# Staff Report

## Site Plan Review

SP-29-19

**Re: Site Plan Review: SP-40-18R (re-submittal)**  
**Project Name: Restaurant Addition for Rancho la Hacienda Real**  
**Site Address: 2845 Santiam Hwy SE Albany, OR 97322**  
**Tax Lots/ID: Lot 1203/108270 & Lot 1202/108262**

CITY OF ALBANY, OREGON PUBLIC WORKS DEPARTMENT	
GRADING & STORMWATER PLAN	
NEW/EXISTING REDEVELOPMENT	
1"=20'-0"	
NO SCALE	JANUARY 2018
NO. 304	NO. 304

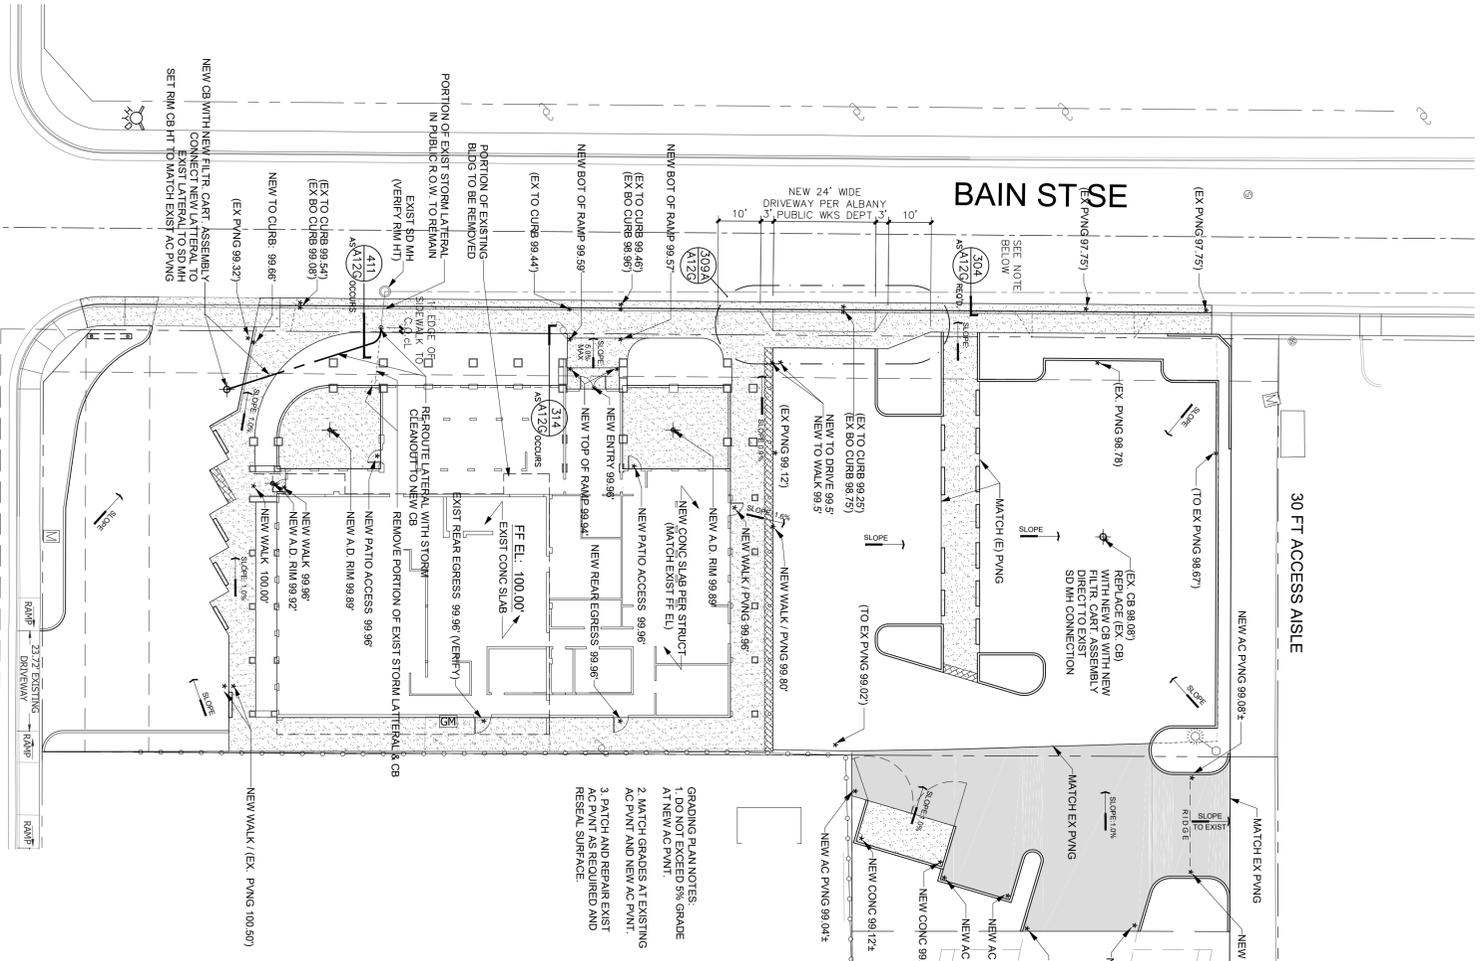
- 1.8 ADC 12.530 states that a development will be approved only where adequate provisions for storm and flood water run-off have been made, as determined by the City Engineer. All stormwater runoff produced on the site (including parking areas, sidewalks, roof drains, etc.) must be collected on-site and routed to the public storm drainage system in Bain Street. No stormwater is allowed to sheet flow from the site across sidewalks or onto adjacent properties.

- 1.9 The applicant's site plan submittal indicates that the redevelopment of the site will result in a total reduction in the amount of impervious surface area on the subject properties, so no on-site stormwater detention will be required.

The existing stormwater from the northern parking area will continue to flow towards the existing (upgraded) catch basin location. 1,700 sq.ft. of new ac pavement area will be added to this area located at the east side will be graded to direct the flow towards this catch basin. The existing parking area at the southern end will also remain and be resealed and restriped with minor reconfigurations. The stormwater from this area will continue to flow towards the existing (upgraded and relocated) catch basin. Please refer to sheet A12G Grading and Stormwater plan.
